CITY OF WEST COVINA

PLANNING COMMISSION

**SEPTEMBER 24, 2019, 7:00 PM
REGULAR MEETING**

2. **GENERAL PLAN AMENDMENT NO. 18-02
ZONE CHANGE NO. 17-02 (QUEEN OF THE VALLEY HOSPITAL SPECIFIC PLAN)
CERTIFICATION OF AN ENVIRONMENTAL IMPACT REPORT
APPLICANT: Emanate Health (formerly Citrus Valley Health Partners)
LOCATION: 1115 and 1135 S. Sunset Avenue**

Exhibit 5.2, Setbacks

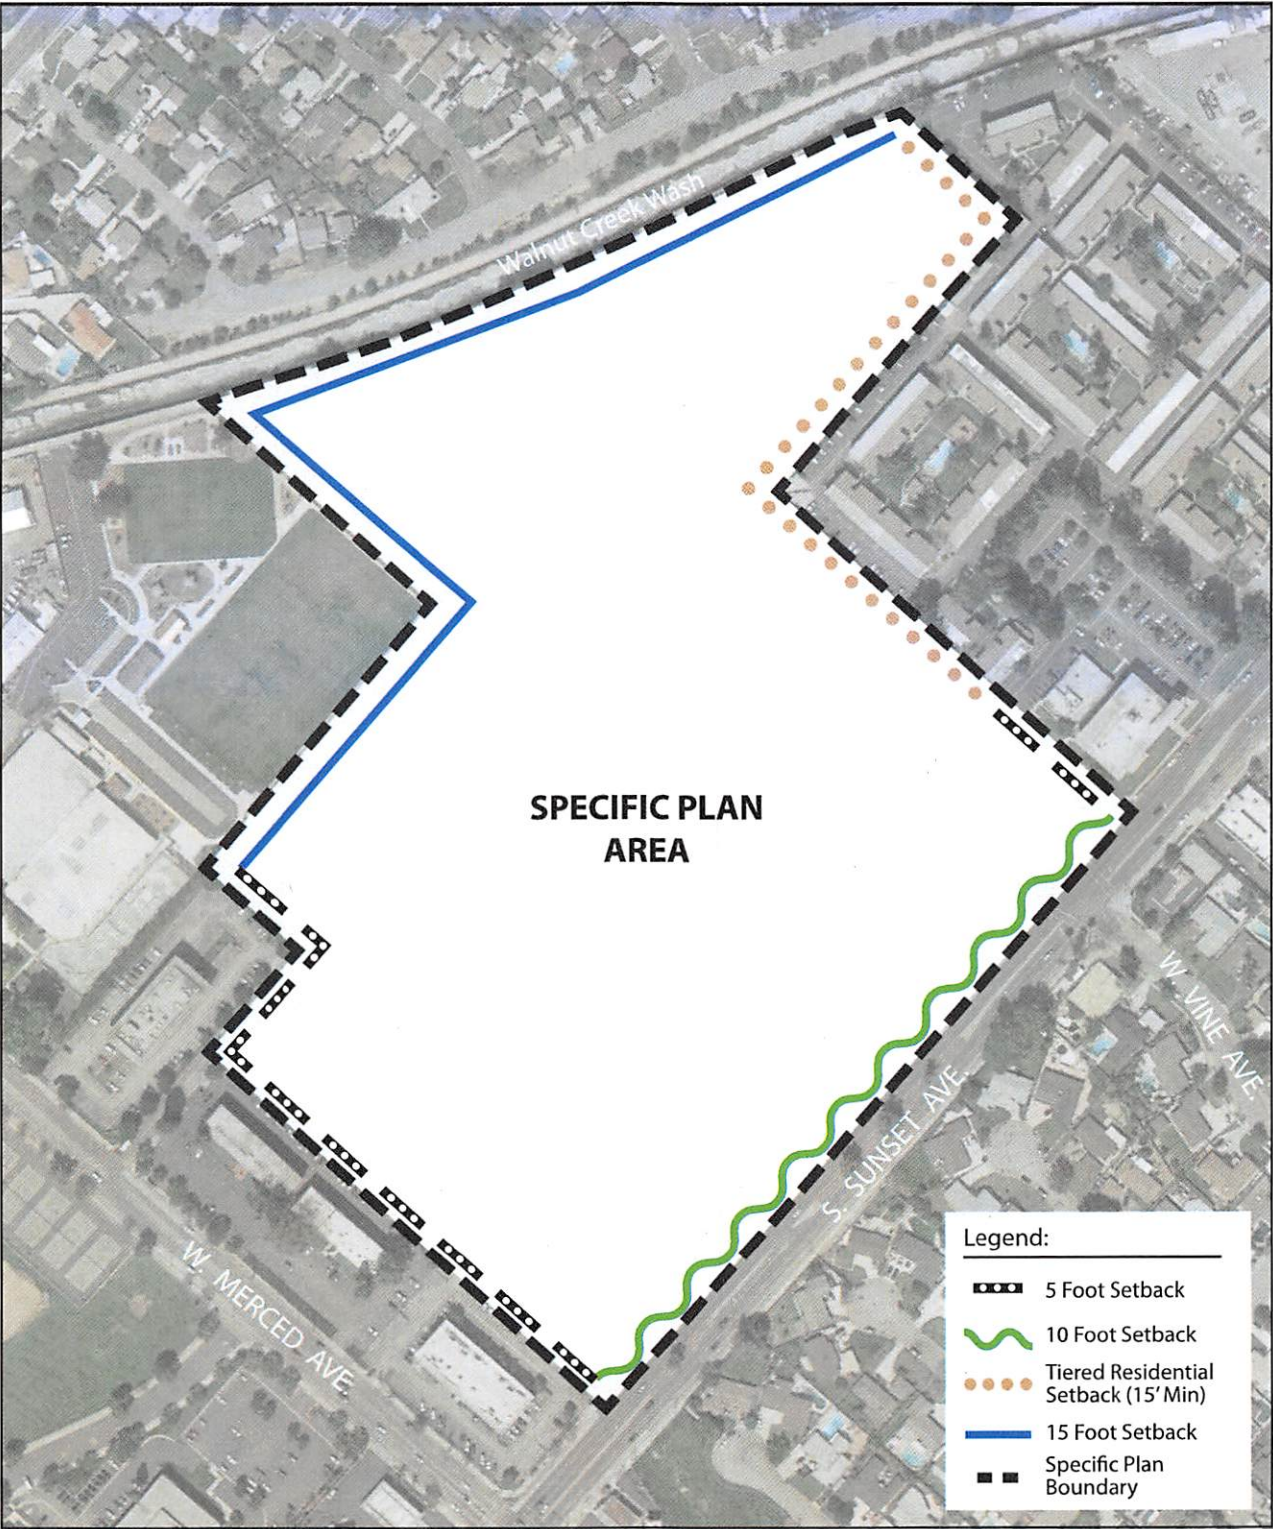
The Torrey Pines complex directly abuts Zone 3, the former Sunset Field property, as well as the easterly boundary of Zone 1, as shown on the attached Exhibits 1.4 and 5.2 from the Specific Plan. Torrey Pines is adjacent to the “Tiered Residential Setback” boundary denoted by beige dots on Exhibit 5.2 (the “Torrey Pines Boundary”).

1. **Parking Structure Setback.** The Final EIR provides that “Parking structures would have a minimum setback of 70 feet from residential uses.” The 70-foot setback for parking structures should be added to the Specific Plan in the Setbacks section on page 5-10, to Exhibit 5.2, Setbacks at page 5-11 and to Section 5.5.3 Parking Structure Design Standards on page 5-22.

4. Ground-Mounted Equipment. The Specific Plan, at page 5-16, provides that ground-mounted equipment can be allowed within a setback area through an Administrative Review by the Planning Director. We request that the Specific Plan be revised to prohibit ground-mounted equipment within the 15-foot “Tiered Residential Setback” along the Torrey Pines Boundary shown on Exhibit 1.4 and depicted in Exhibit 5.5 on page 5-13.
